UNITED STATES PATENT AND TRADEMARK OFFICE

APPLICATION NO.	FILING DATE	FIRST NAMED INVENTOR	ATTORNEY DOCKET NO.	CONFIRMATION NO.
09/779,788	02/07/2001	Behrooz Rezvani	VELCP009C	7770
28436	7590	06/08/2005	EXAMINER	
IP CREATORS P. O. BOX 2789 CUPERTINO, CA 95015			DEPPE, BETSY LEE	
			ART UNIT	PAPER NUMBER
			2637

Office Action Summary

DETAILED ACTION

FIG. 7A

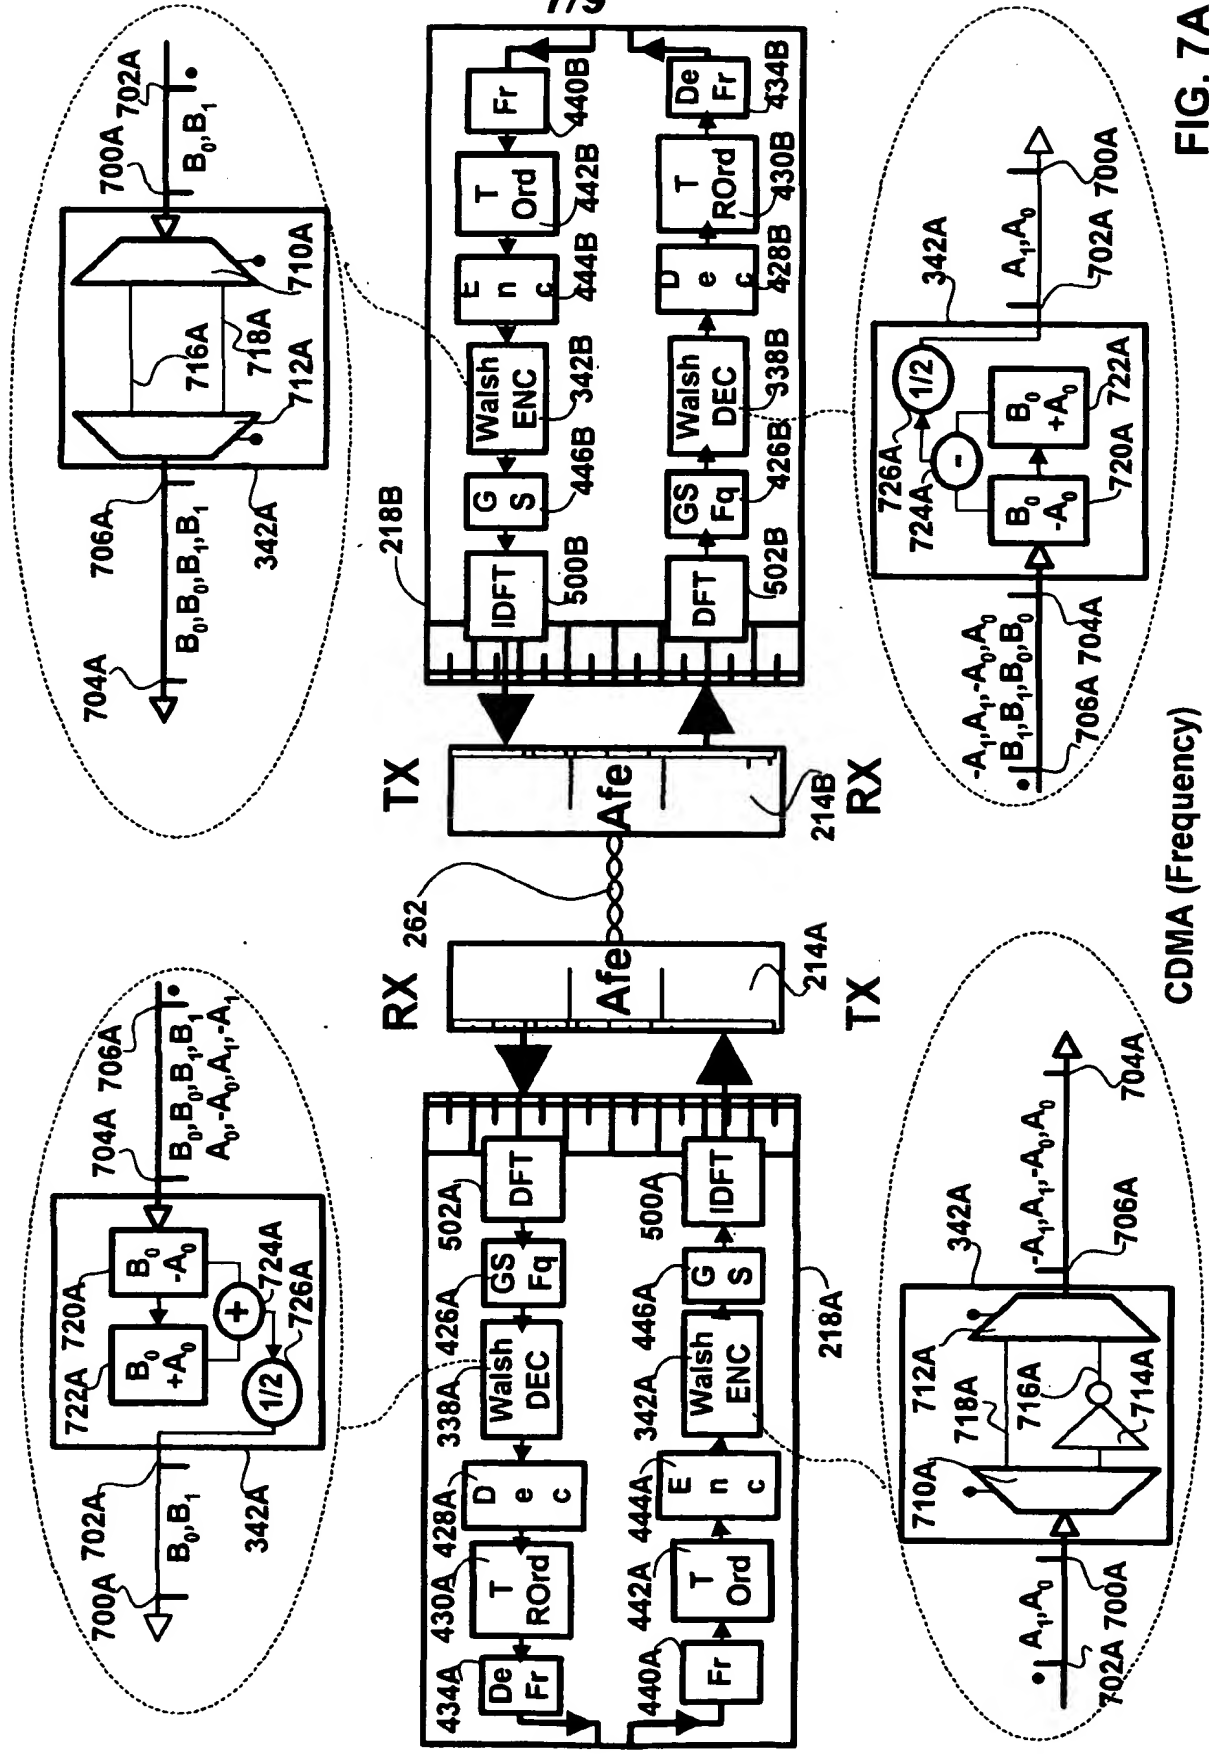
1. The drawings were received on January 24, 2005. These drawings are accepted.
2. The drawings are objected to as failing to comply with 37 CFR 1.84(p)(4) because reference character "724A" has been used to designate both an adder and a subtractor in Figures 7A and 7B. Since page 16, line 24, refers to "724A" as "summers," it appears that the subtractor in Figures 7A and 7B should be changed to an adder.

Corrected drawing sheets in compliance with 37 CFR 1.121(d) are required in reply to the Office action to avoid abandonment of the application. Any amended replacement drawing sheet should include all of the figures appearing on the immediate prior version of the sheet, even if only one figure is being amended. Each drawing sheet submitted after the filing date of an application must be labeled in the top margin as either "Replacement Sheet" or "New Sheet" pursuant to 37 CFR 1.121(d). If the changes are not accepted by the examiner, the applicant will be notified and informed of any required corrective action in the next Office action. The objection to the drawings will not be held in abeyance.
